611 BROOKFIELD STREET SLURRY RELEASE EVALUATION PROJECT

Wetland Impact Assessment

DEPARTMENT OF DEVELOPMENT SERVICES – PLANNING DIVISION
REPORT: Summary of Wetlands Violation, MDC SHCST, 611 Brookfield St.
 for consideration March 9, 2021

SUBJECT: Communication/Discussion Related to Wetlands Violation at The
 Metropolitan District Commission (MDC) South Hartford Conveyance
 and Storage Tunnel (SHCST), Site DS-2
 Accela Code Case #: 9636459

Figure 1. Photograph from AECOM depicting slurry waste that leaked from 611 Brookfield St. onto the adjacent property owned by the City of Hartford Housing Authority, which contains the South Branch of the Park River and associated wetlands and upland review area.

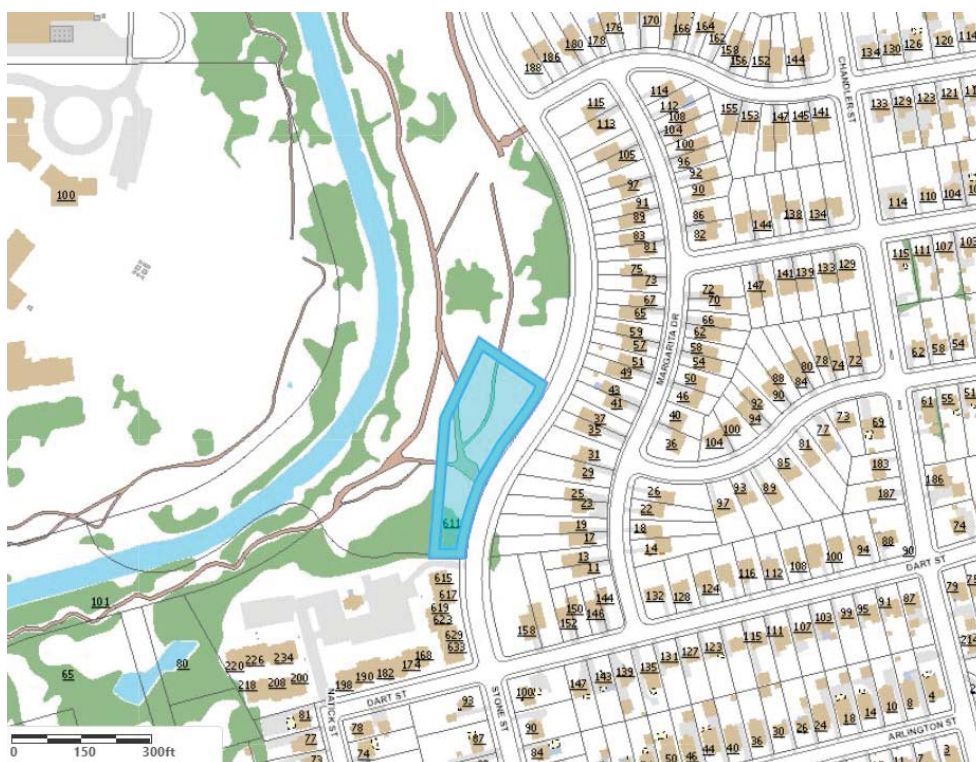
Activities related to the construction of The MDC's South Hartford Conveyance and Storage Tunnel (SHCST) Site DS-2 at 611 Brookfield St. have resulted in depositing material into an adjacent wetlands, watercourse, and upland review area without approvals or permits. A Notice of Violation dated March 2, 2021 was issued to the property owner's representative via e-mail, certified mail, and regular mail (see Attachment #1).
